USE PERMIT

RE: Assisted Living Facility (Class "A")

PLAT TO ACCOMPANY PETITION FOR
CHANGE OF OCCUPANCY
9402 BELAIR ROAD
11th ELECTION DISTRICT
BALTIMORE COUNTY, MARYLAND
DATE: SEPTEMBER 25, 2001 SCALE: 1"=20'

PERMIT PLAN FOR CLASS "A" ASSISTED LIVING FACILITY (ALF)
AND PLAT TO ACCOMPANY PETITION FOR
CHANGE OF OCCUPANCY
9402 BELAIR ROAD
11th ELECTION DISTRICT
BALTIMORE COUNTY, MARYLAND
DATE: SEPTEMBER 25, 2001 SCALE: 1"=20' 21139

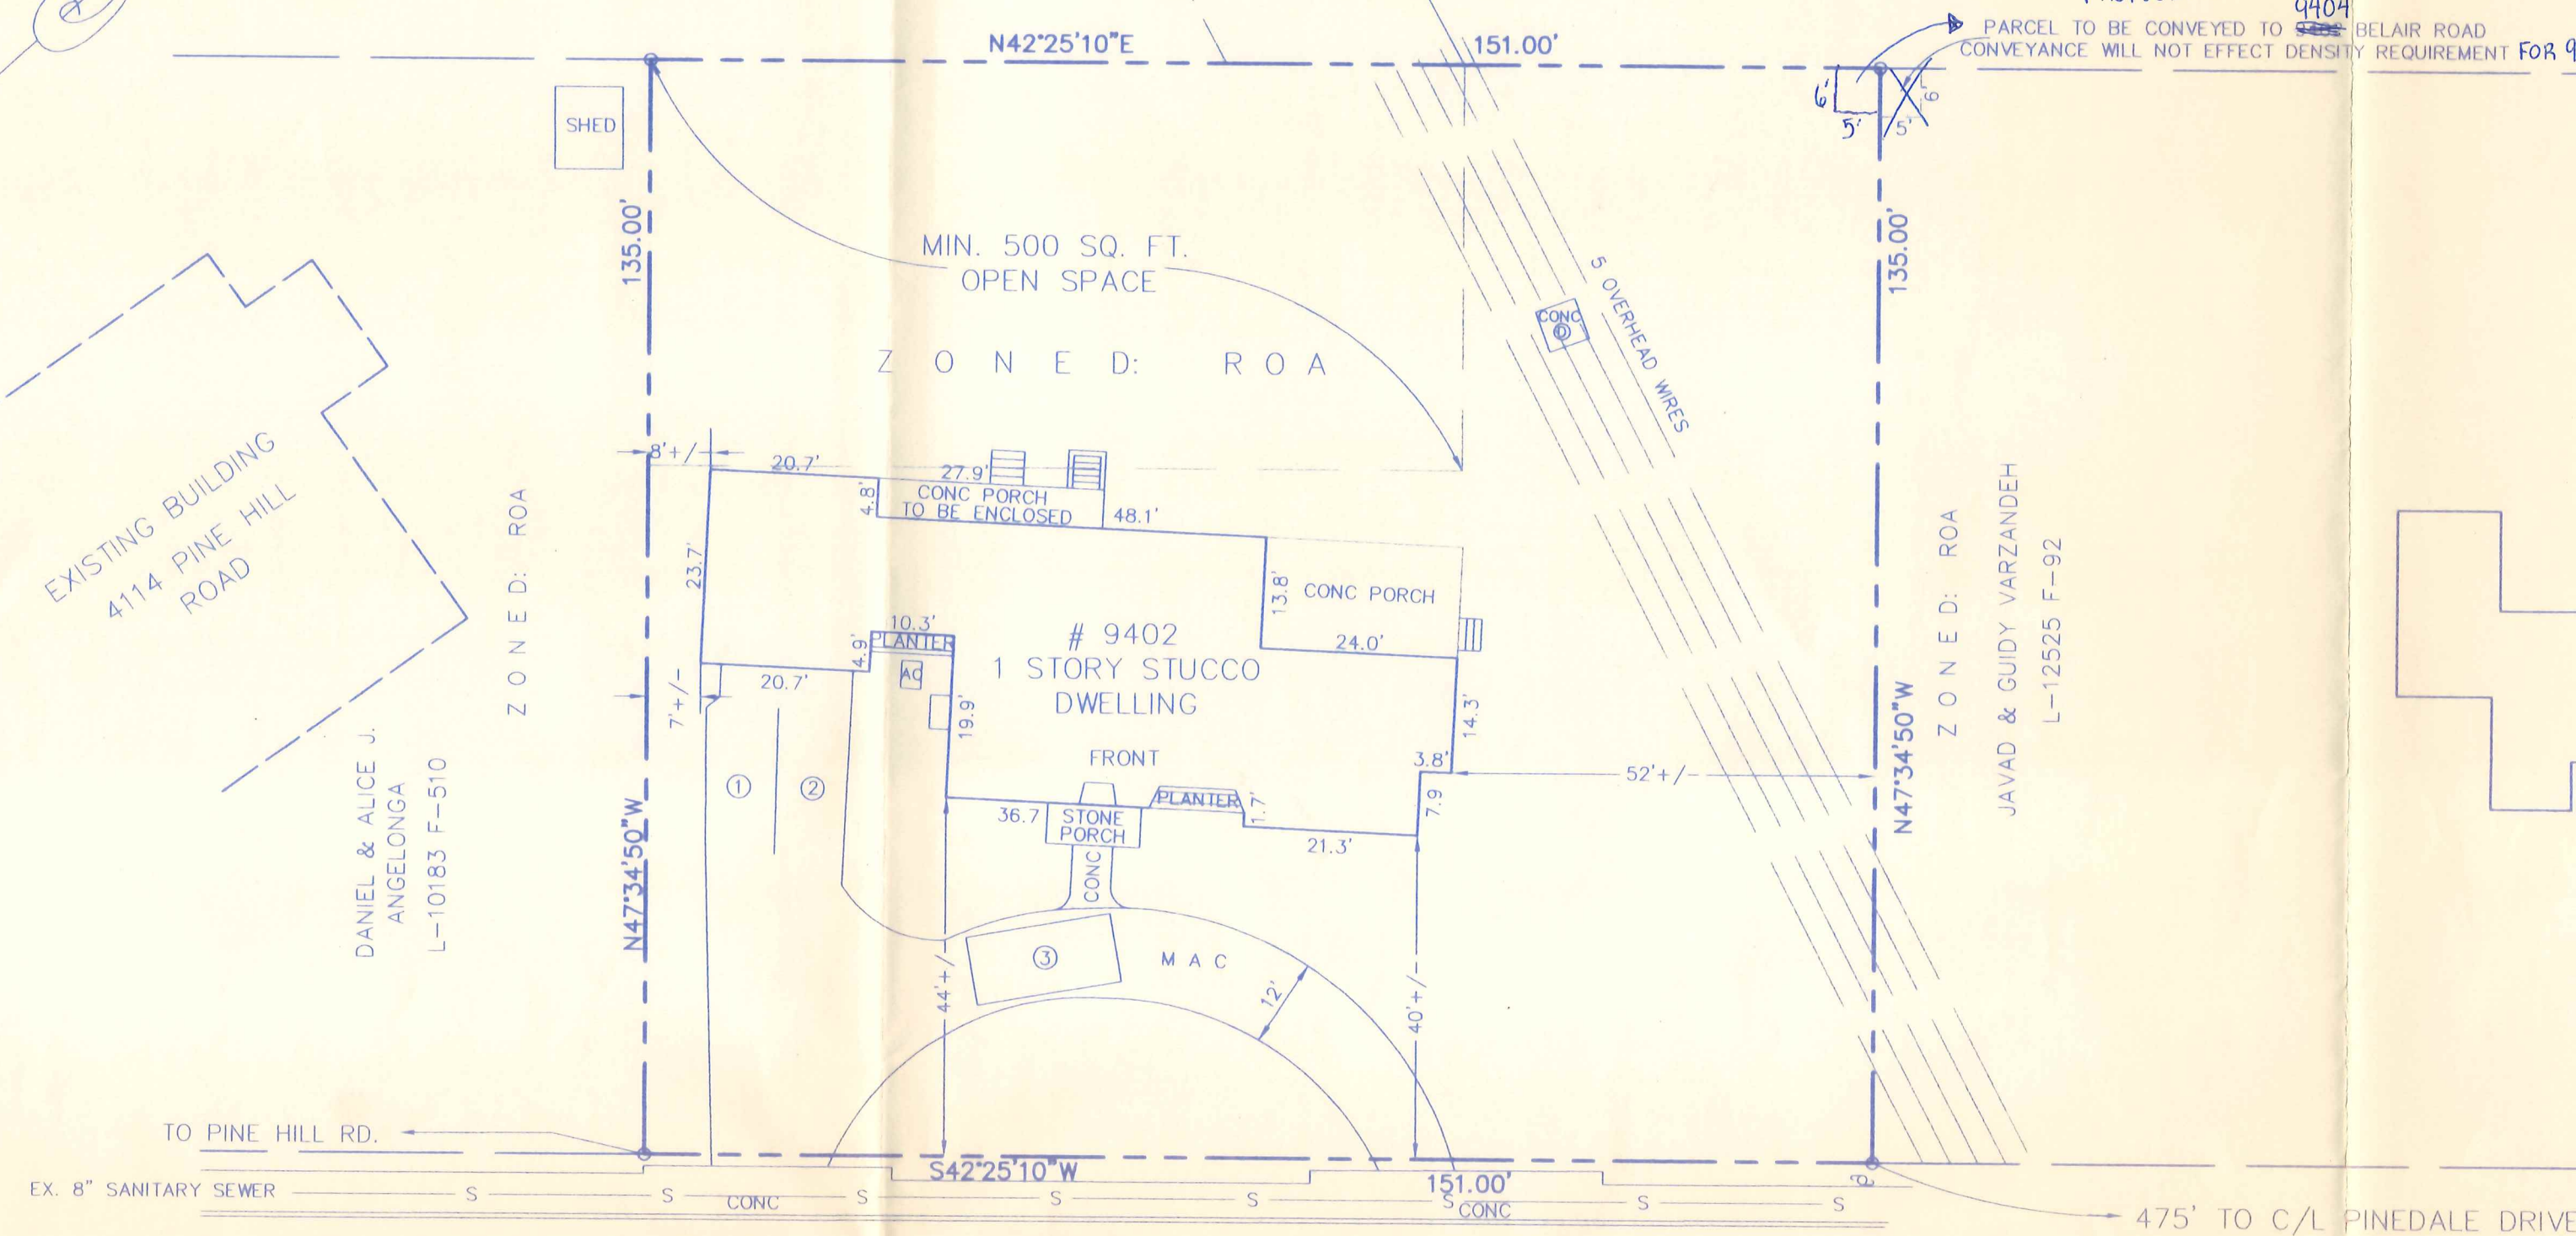
Staff supports the request to permit the conversion of 9402 Belair Road to a Class A Assisted Living Facility. The site is zoned ROA, hence the facility is subject to the requirements of a DR 3.5 zone. The property meets the area requirements; however, this office is concerned about parking. The plan shows two spaces within the front yard and a third space in the driveway. The space in the driveway seems unrealistic and should be relocated.

Additionally, a landscape plan should be submitted to the Office of Planning for review and approval prior to a change in occupancy. The plan should show outdoor amenities such as shade trees, a gazebo, and/or a bench, etc. Also, the front yard should be visually enhanced with landscaping.

- 14) Existing parking and maneuvering area existed Prior to 2/25/1994
- 15) Parking required at 1 space per 3 beds = 3 spaces 8 1/2' x 18' Provided 3 spaces, permanently striped
